JULY 26, 2023
ADDENDUM NO. 1

ADDENDUM #1

**VAN NESS AVENUE
FROM REDONDO BEACH BOULEVARD TO MARINE AVENUE**

PROJECT NO. JN 992

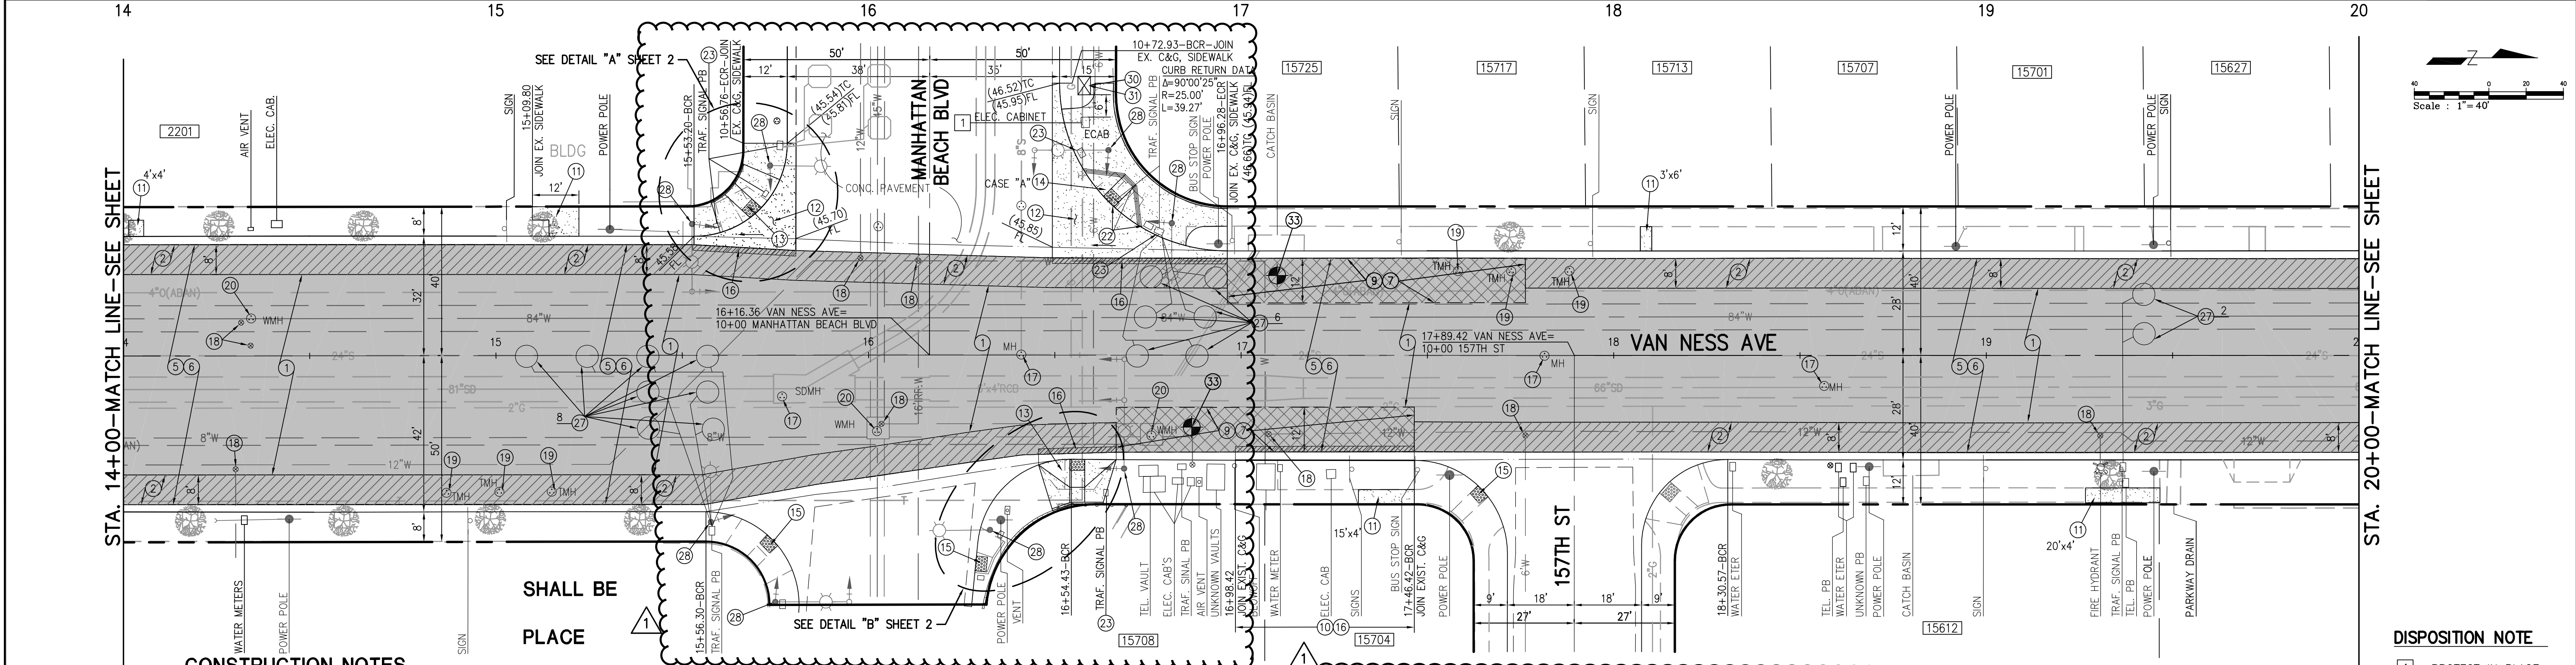
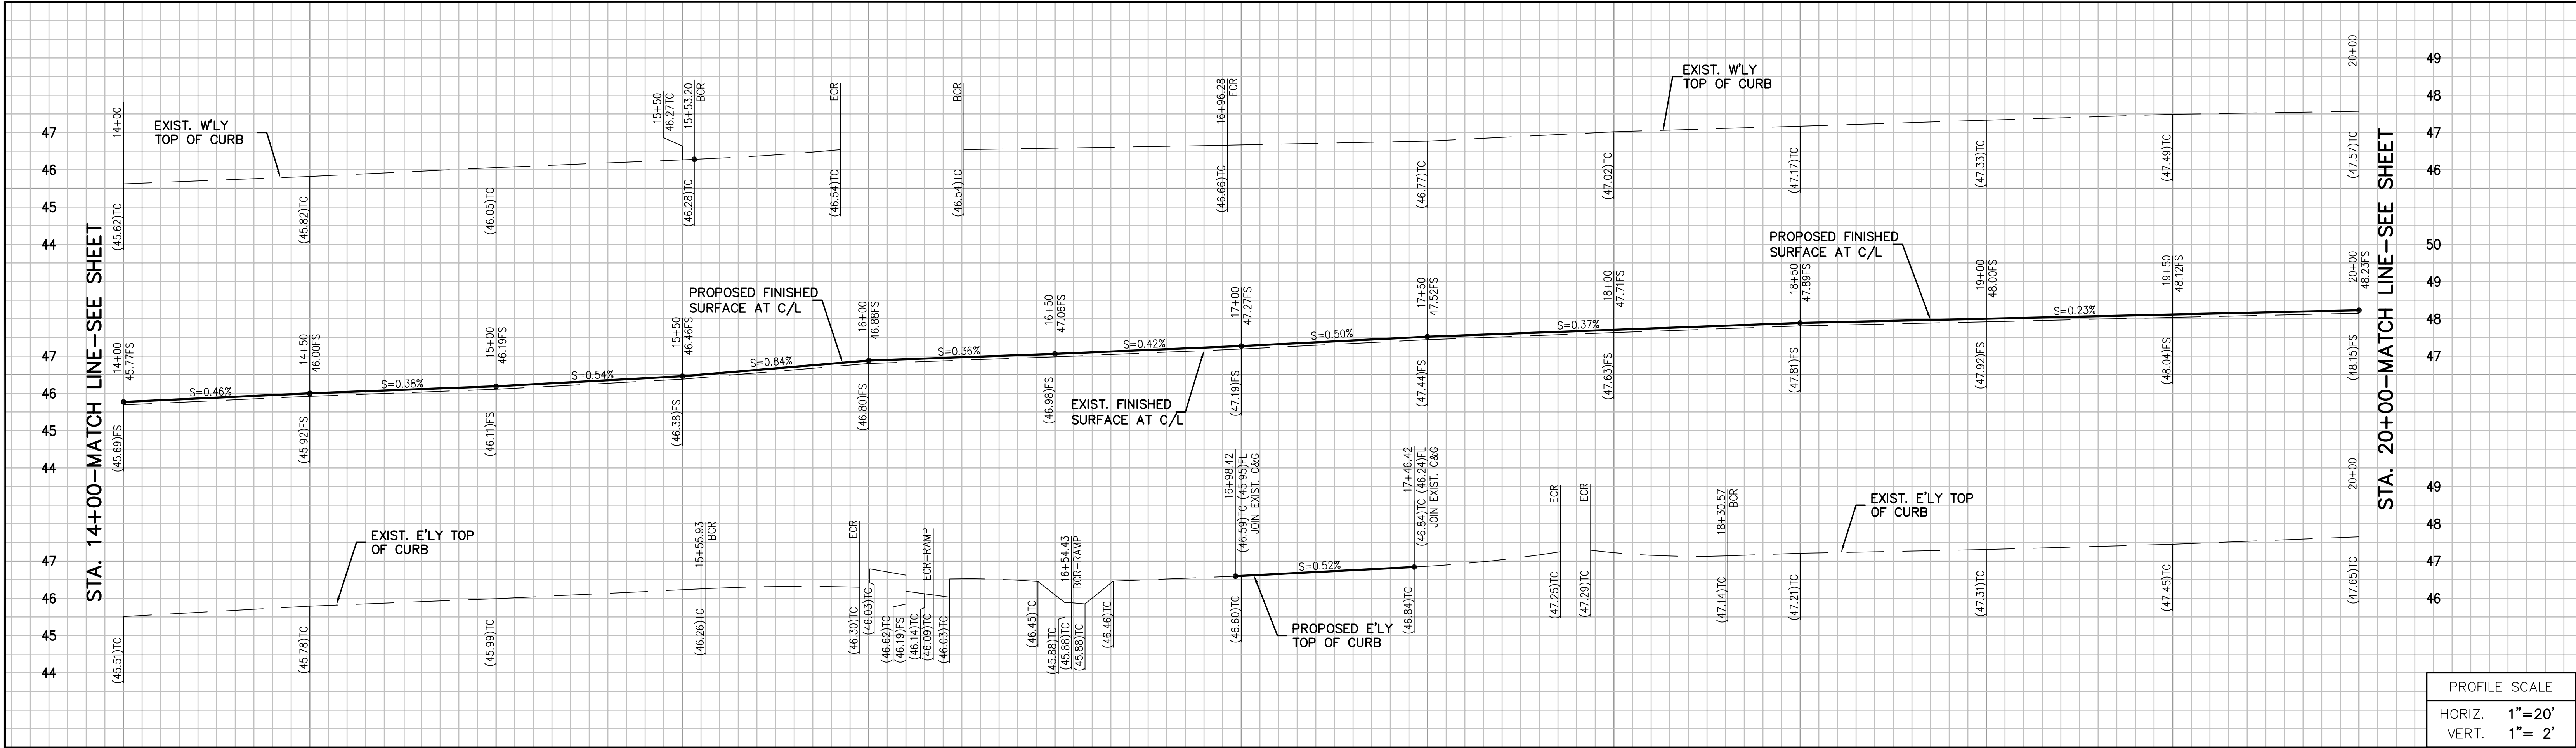
Revised Plan Sheets 1,4,5,6 and 8 are enclosed which depict the revisions to construction notes and installation of pedestrian push buttons at the Manhattan Beach, 156th Street, and Marine Avenue intersections.

- REMOVE AND SALVAGE EXISTING PUSH BUTTON, FURNISH AND INSTALL "INS" INAVIGATOR 3-WIRE PUSH BUTTON STATION WITH DETECT TOUCHLESS ACTUATION OPTION AS SPECIFIED IN PROJECT SPECIFICATIONS.
- FURNISH AND INSTALL NEW BBS CABINET AS SPECIFIED IN PROJECT SPECIFICATIONS.
- REMOVE EXISTING TREE.
- CONDUCT PAVEMENT CORES IN ACCORDANCE WITH PROJECT SPECIFICATIONS.

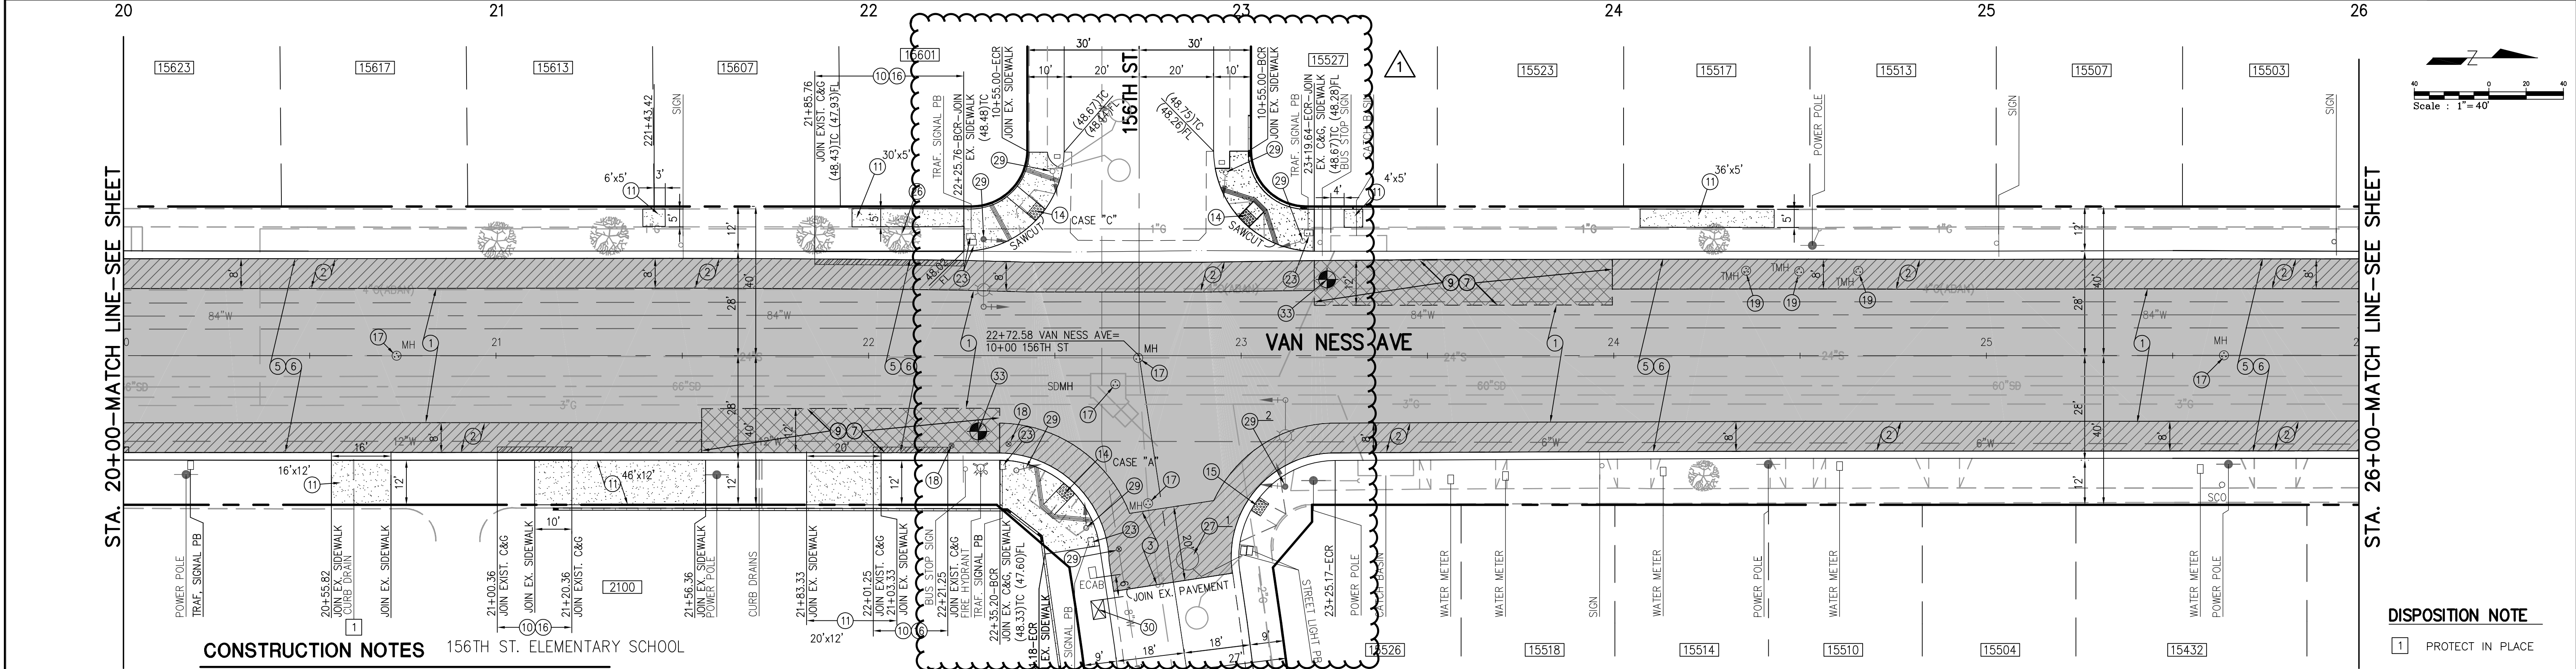
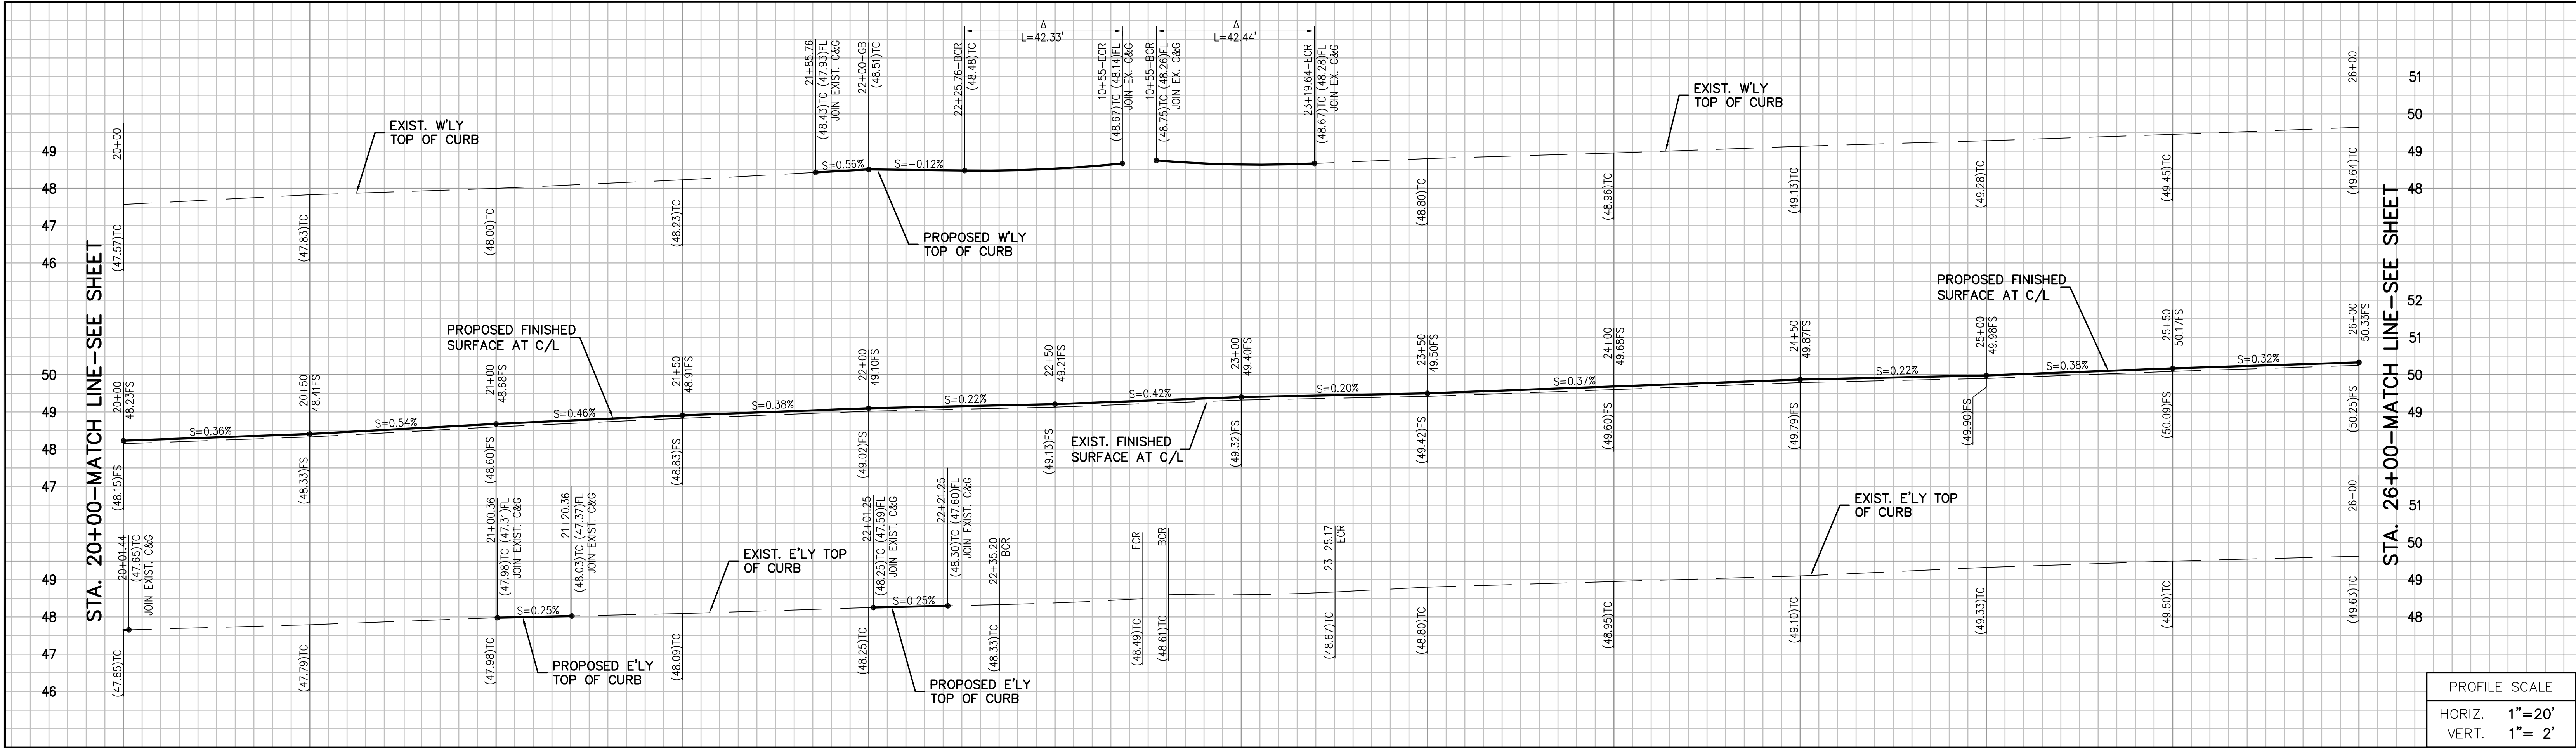
- 29 FURNISH AND INSTALL "INS" NAVIGATOR 3—WIRE PUSH BUTTON STATION WITH IDETECT TOUCHLESS ACTUATION OPTION AS SPECIFIED IN PROJECT SPECIFICATIONS.
- 30 FURNISH AND INSTALL NEW BBS CABINET AS SPECIFIED IN PROJECT SPECIFICATIONS.
- 33 CONDUCT PAVEMENT CORES IN ACCORDANCE WITH PROJECT SPECIFICATIONS.

SHT. **6** OF **11**

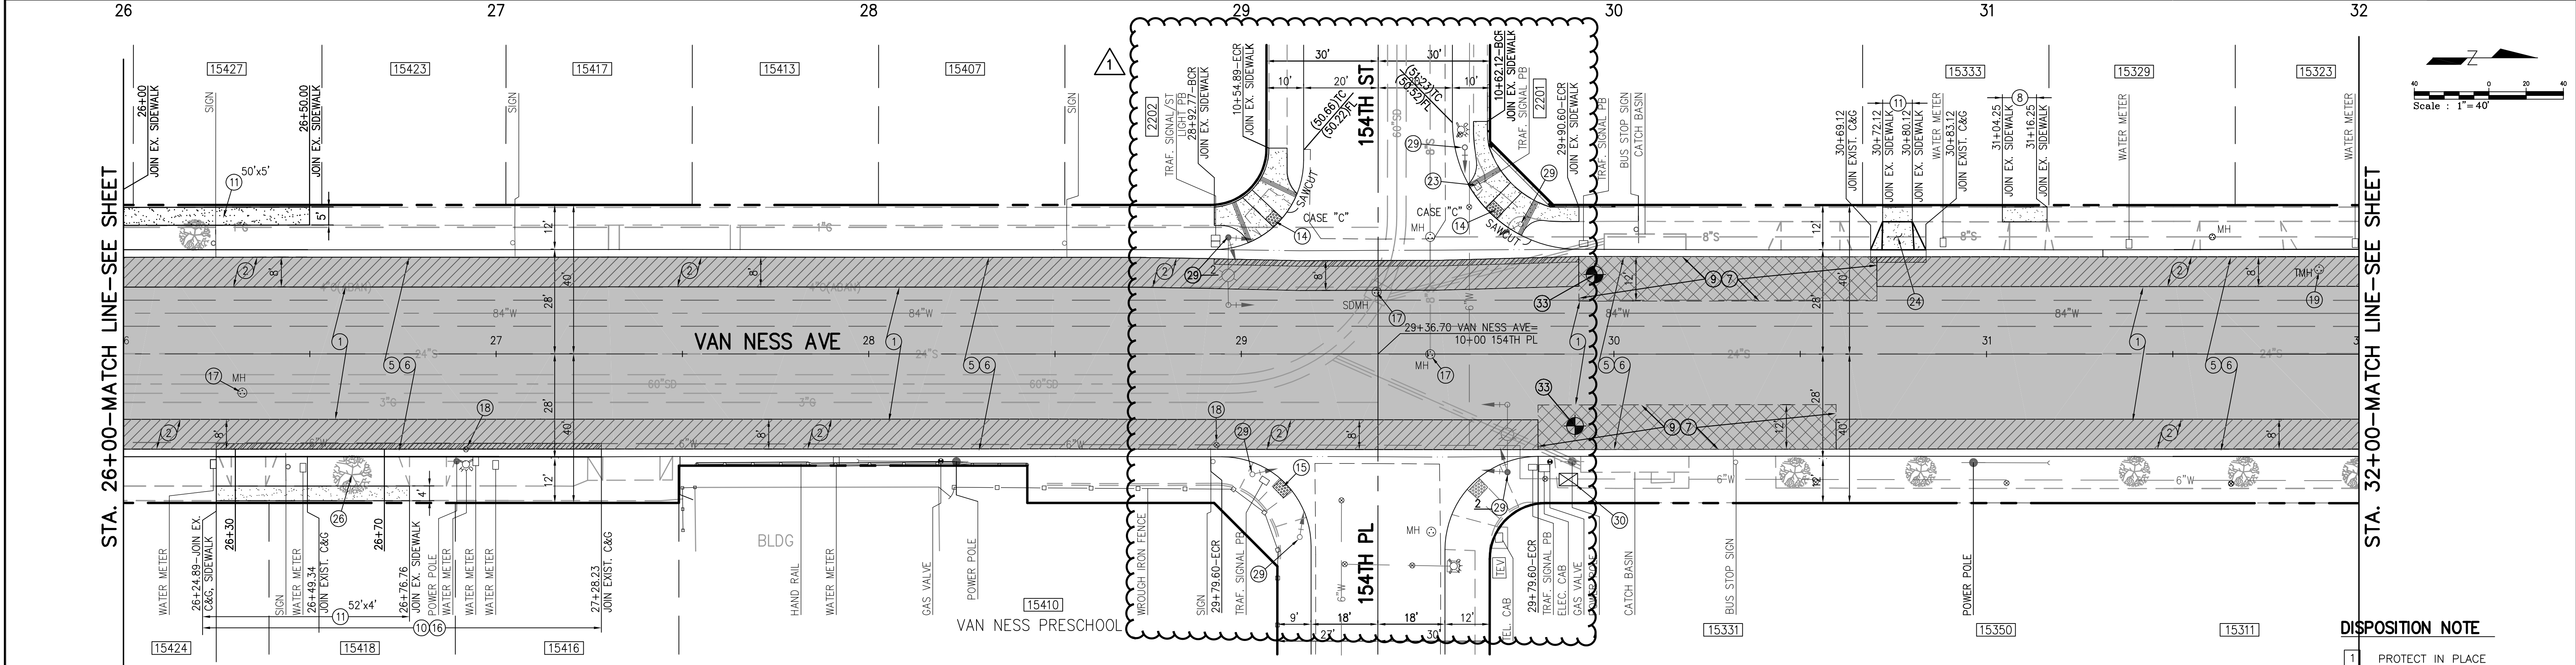
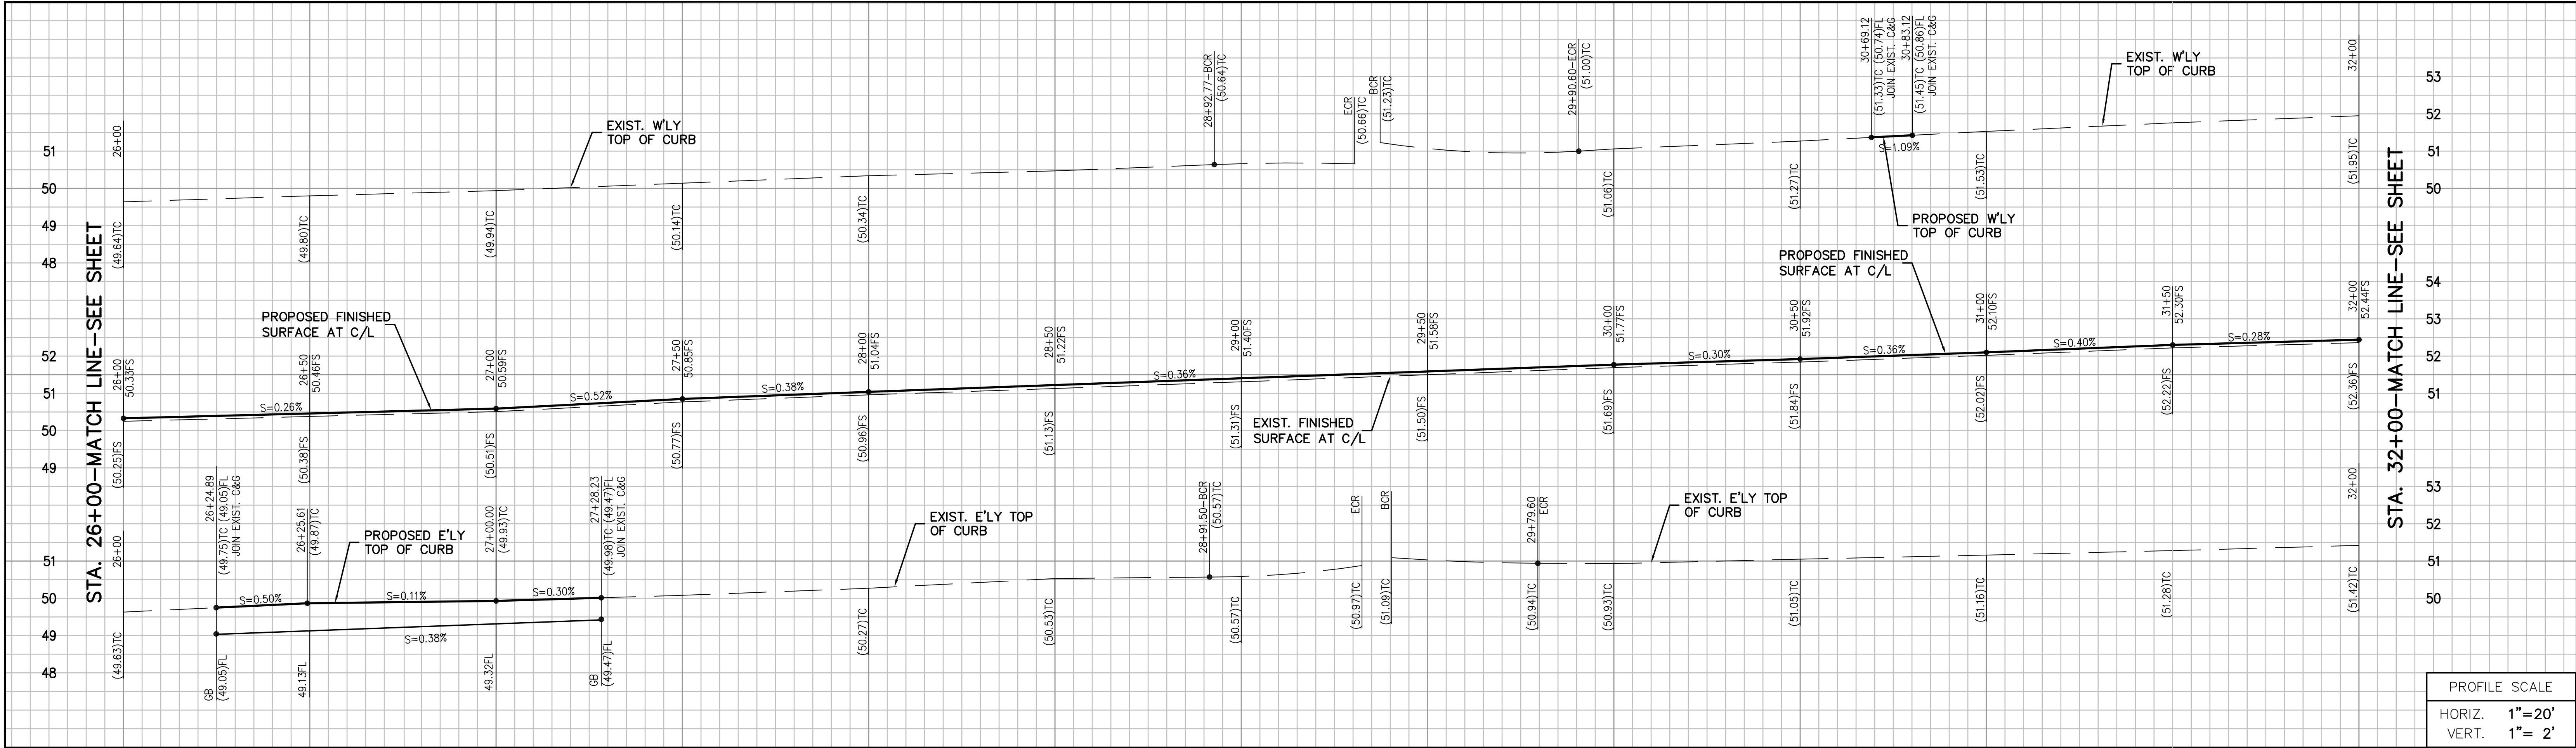
- 29 FURNISH AND INSTALL "INS" NAVIGATOR 3-WIRE PUSH BUTTON STATION WITH IDETECT TOUCHLESS ACTUATION OPTION AS SPECIFIED IN PROJECT SPECIFICATIONS.
- 30 FURNISH AND INSTALL NEW BBS CABINET AS SPECIFIED IN PROJECT SPECIFICATIONS.
- 33 CONDUCT PAVEMENT CORES IN ACCORDANCE WITH PROJECT SPECIFICATIONS.
